**Agenda**  
**Hailey Planning and Zoning Commission**  
**Tuesday, January 21, 2025**  
**5:30 p.m.**

## FINDINGS OF FACT, CONCLUSIONS OF LAW AND DECISION

**Overview:** Consideration of a Planned Unit Development (PUD) Application submitted by St. Charles Borromeo Catholic Church, represented by The Land Group, Inc., to consider various waivers and benefits of the zoning and subdivision codes to be able to construct a new Parish Hall, Classrooms, Administrative Offices, Worship Sanctuary, as well as repurpose the existing church building, all located at 311 South 1st Avenue (Lots 3-10, Block 21, Townsite Overlay) within the Transitional (T) and Townsite Overlay (TO) Zoning Districts. As part of the community benefit, the PUD Application proposes offsite sidewalk improvements in the vicinity of the project site. This includes improvements to South 1st Avenue and East Pine Street, as well as East Walnut Street, to South Main Street. Additional community benefits will be discussed throughout multiple Public Hearings for this PUD Application. As part of the Application, the Applicant requests the following waivers:

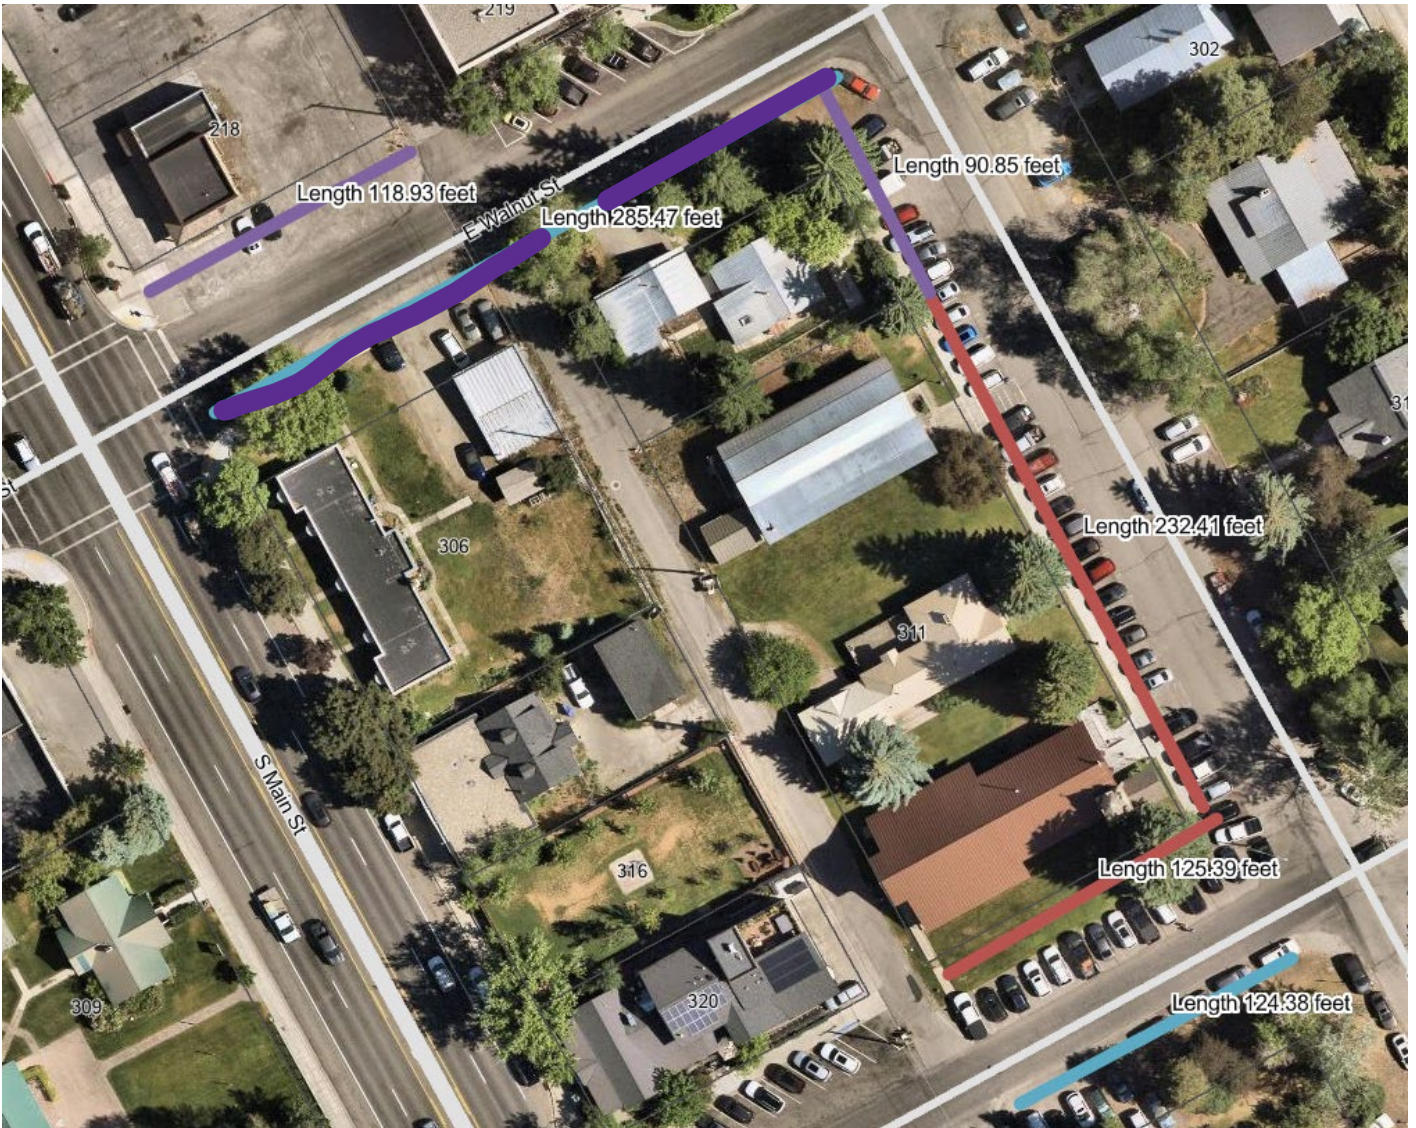
Public Works and Streets Division Managers have preliminarily reviewed these proposed improvements, and they have approved the selected locations. Style, scope, and specific design details for improvements may continue to be discussed throughout the PUD Application review process. The Commission may wish to offer additional feedback or recommendations throughout iterations of Public Hearings.

**In purple:** full vehicular and pedestrian improvements; see "full street section" description below.

**In blue:** only angled parking, including paving and striping where necessary\*.

\*Public Works has recommended that along East side of the Walnut Street alley, along Walnut, that no parking is provided. This is due to the degree of slope on that section of street, which would make parking – especially in the winter – difficult to access for pedestrians and challenging to maintain. However, they do recommend a full street section of pedestrian improvements in this area.

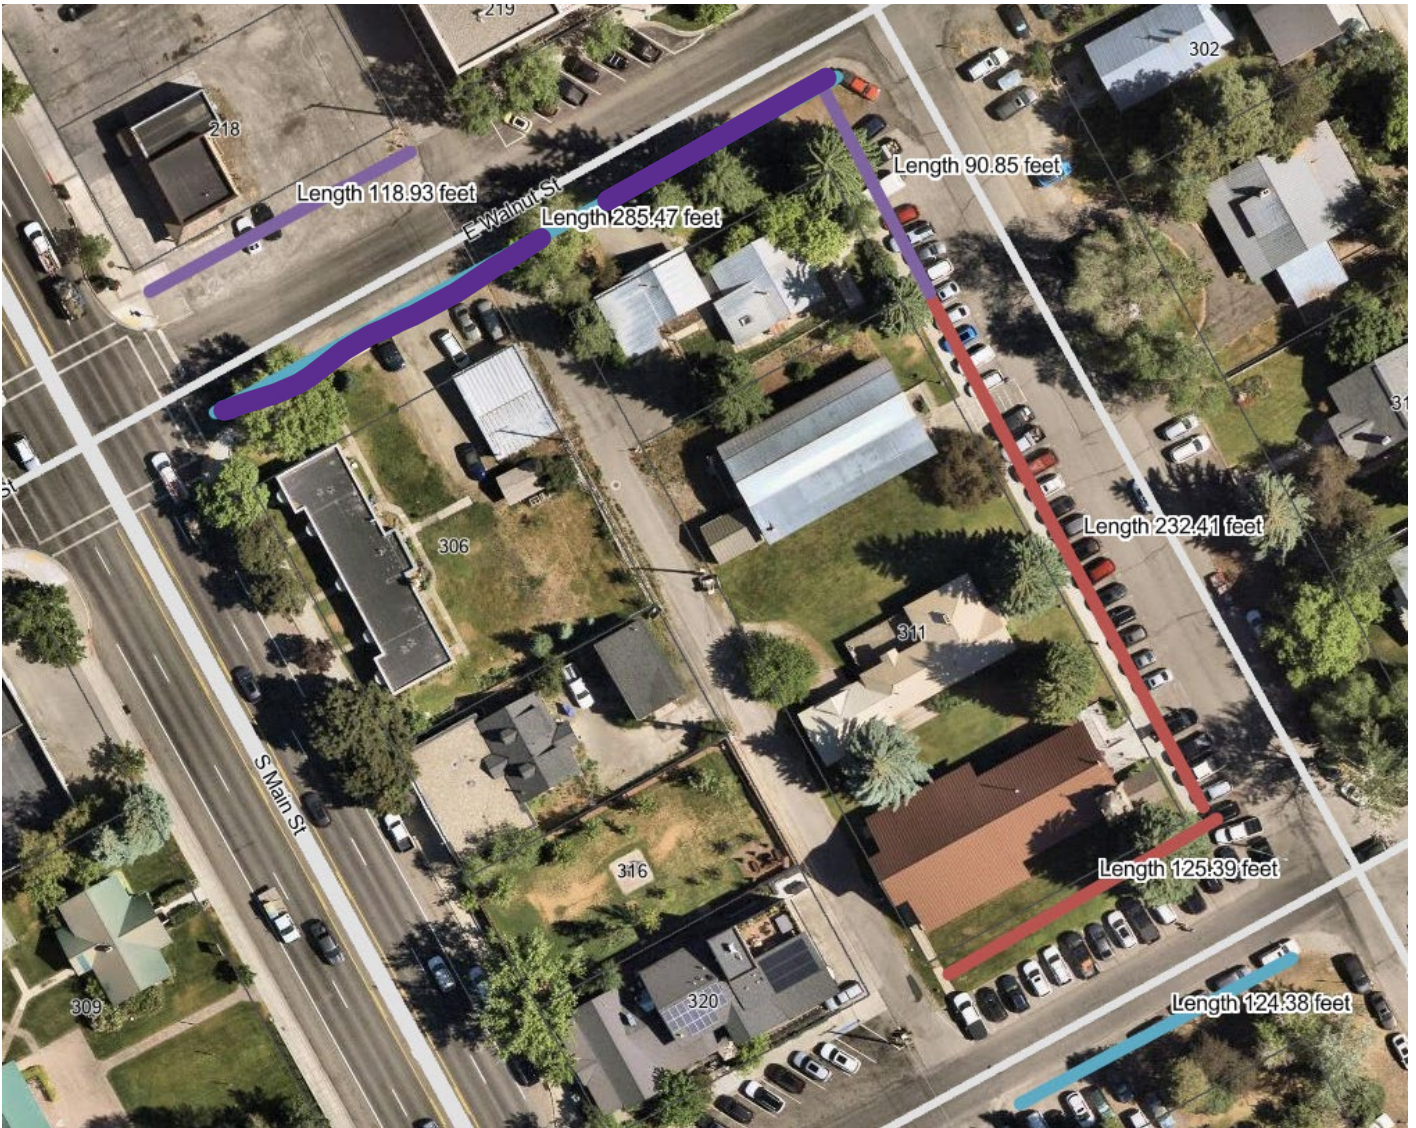
**In purple:** full vehicular and pedestrian improvements; see "full street section" description below.

**In blue:** only angled parking, including paving and striping where necessary\*.
